ADDENDUM

ADDENDUM NO.: **03**

PROJECT NAME: **Skinner West Elementary School Annex**

DATE OF ISSUE: **August 1, 2017**

C2.0

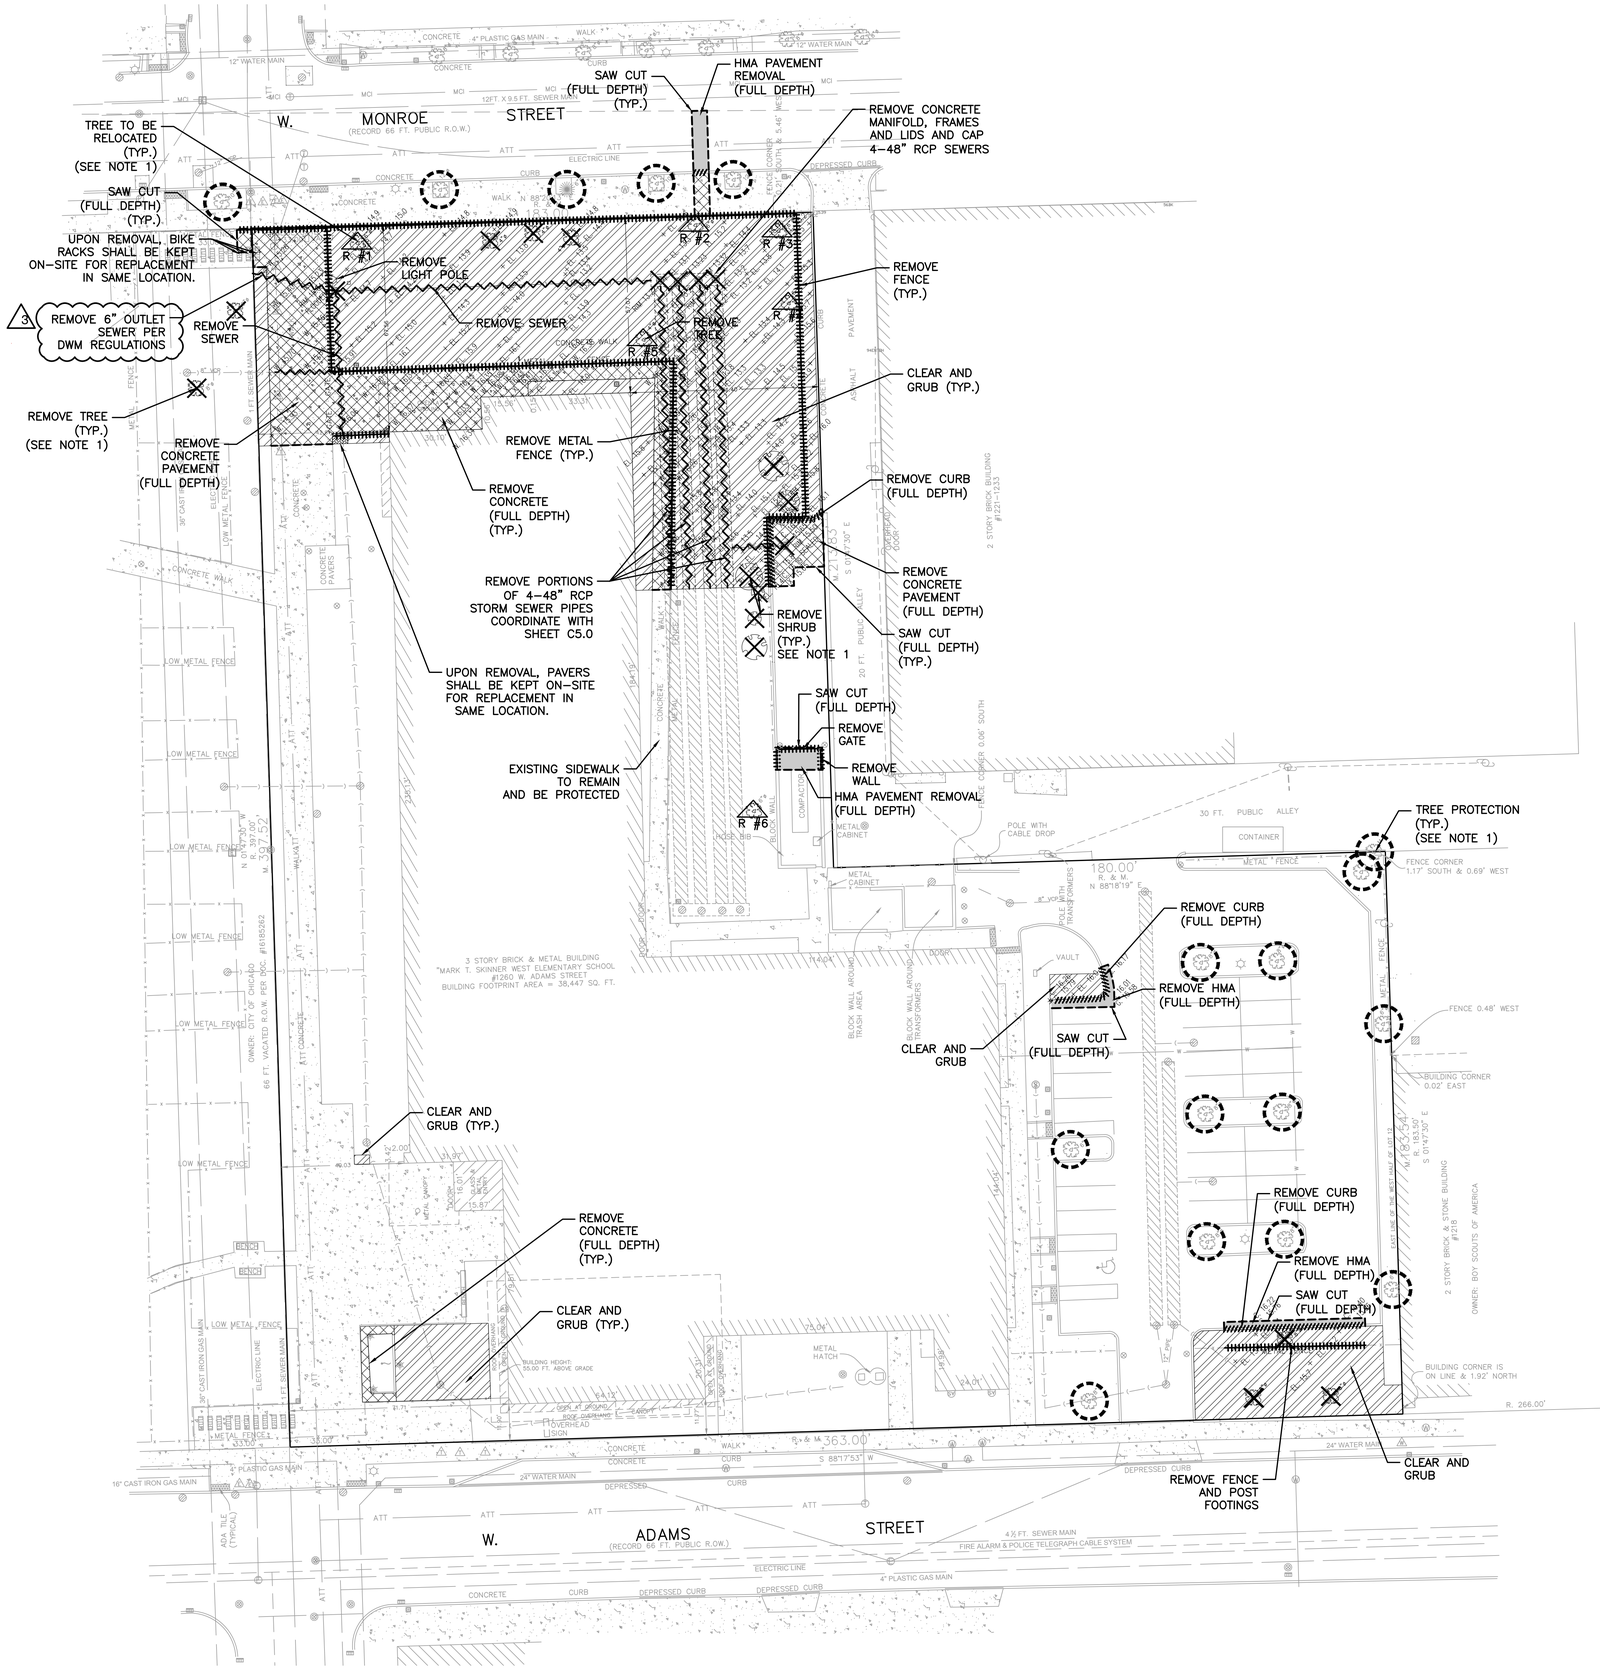
Change 1 Sheet C2.0 **ADDED:** Removal of Existing 6-inch Storm Outlet Sewer
Change 2 Sheet C5.0 **ADDED:** MH-1 at 12-inch x 12-inch Connection
Change 3 Sheet C5.0 **ADDED:** MH-2 StormTrap Access Manhole with Open Lid
Change 4 Sheet C5.0 **ADDED:** Call-out for Bioinfiltration System
Change 5 Sheet C5.0 **ADDED:** Utility Note No. 4
Change 6 Sheet C5.0 **ADDED:** Storm Connection from Existing Roof Drain to Proposed Storm on East Side of Existing Building
Change 7 Sheet C5.0 **REVISED:** Outlet Sewer to 6-inch at 1.0% Slope
Change 8 Sheet C5.0 **REVISED:** Diameter Restrictor Plate
Change 9 Sheet C5.0 **REVISED:** Call-outs for Utility Trench Detail
Change 10 Sheet C7.1 **REVISED** Detail 2; **REMOVED** Detail 4 and Revised Detail Numbers / References Accordingly
Change 11 Sheet C7.2 **REVISED** Detail 1 to Eliminate Reference to Vortex Restrictor
Change 12 Sheet C8.0 **ADDED** MH-1 at 12-inch x 12-inch Connection

2 C7.1 CB-1 W/RESTRICTOR
SCALE: NOT TO SCALE

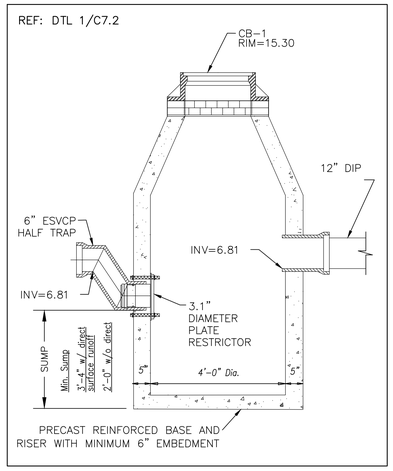
Change 13 Sheet C8.0 **ADDED** MH-2 StormTrap Access Manhole with Open Lid
Change 14 Sheet C8.0 **ADDED** Call-out for Bioinfiltration System
Change 15 Sheet C8.0 **ADDED** Utility Note No. 1
Change 16 Sheet C8.0 **ADDED** Storm Connection from Existing Roof Drain to Proposed Storm on East Side of Existing Building
Change 17 Sheet C8.0 **REVISED** Outlet Sewer to 6-inch at 1.0% Slope
Change 18 Sheet C8.0 **REVISED** CB-3 to 3.1” Diameter Restrictor Plate
Change 19 Sheet C8.0 **REVISED** Call-outs for Utility Trench Detail
